SUNDRY NOTICES AND REPORTS ON WELLS
Do not use this form for proposals to drill or to re-enter an abandoned well. Use form 3160-3 (APD) for such proposals.

5. Lease Serial No. NMNM84898
6. If Indian, Allottee or Tribe Name
7. If Unit or CA/Agreement, Name and/or No.
8. Well Name and No. RATTLESNAKE FED 1
9. API Well No. 30-025-33062-00-S1
10. Field and Pool, or Exploratory RATTLESNAKE FLAT-DELAWARE
11. County or Parish, and State LEA COUNTY, NM

EOG Resources proposes to P&A this well as follows:

RATTLESNAKE 28 FED #1

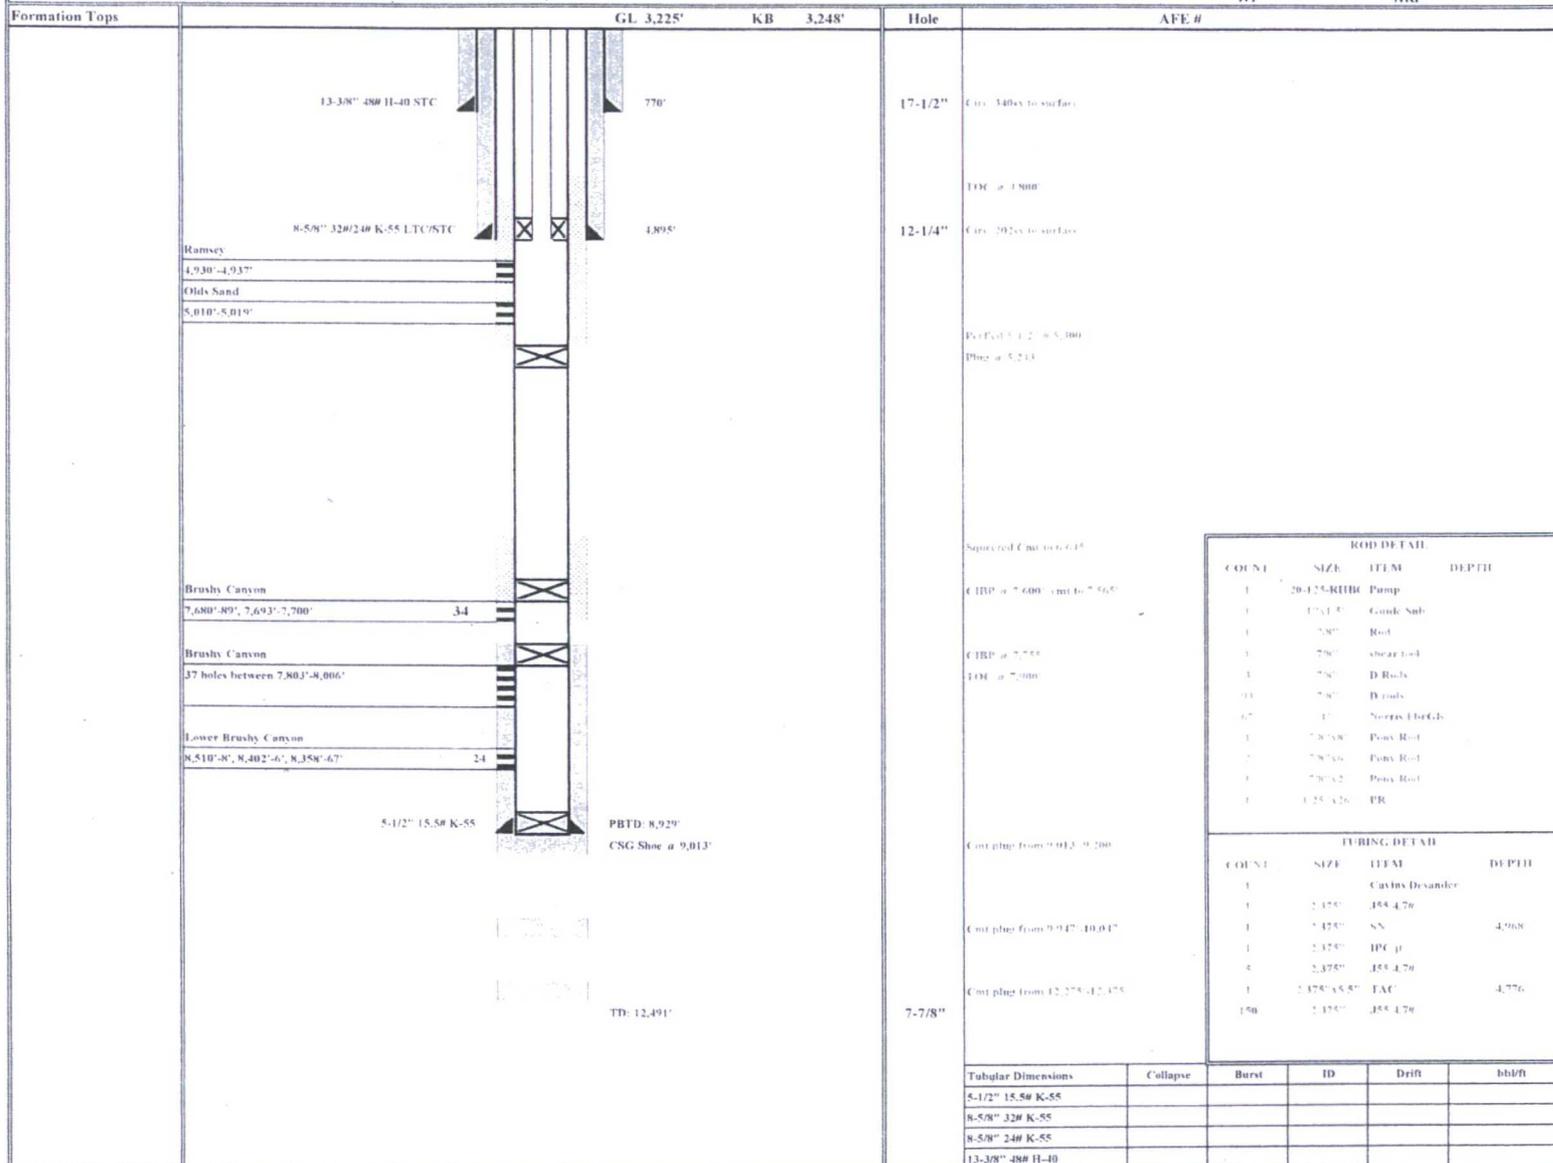
- Set 5-1/2" CIBP @ 4915' - OK
- Perforate 5-1/2" casing @ 4775'
- Circulate 9ppg mud to surface.
- Tag CIBP with tubing and spot 75sx Class C cement at 4915' or just above CIBP. WOC and tag.
- Perforate 5-1/2" casing @ 1150'
- Squeeze 35sx Class C @ 1150' Tag at 1040
- Perforate 5-1/2" @ 820'
- Squeeze 115sx Class C @ 820. WOC and tag. Tag at 720
- Perforate 5-1/2" @ 100'
- Cut off wellhead three feet below surface.

Tag at 4675'

11. Spot ?30sx Class C to get cement to surface across all annuluses.
12. Cut off anchors three feet below surface.
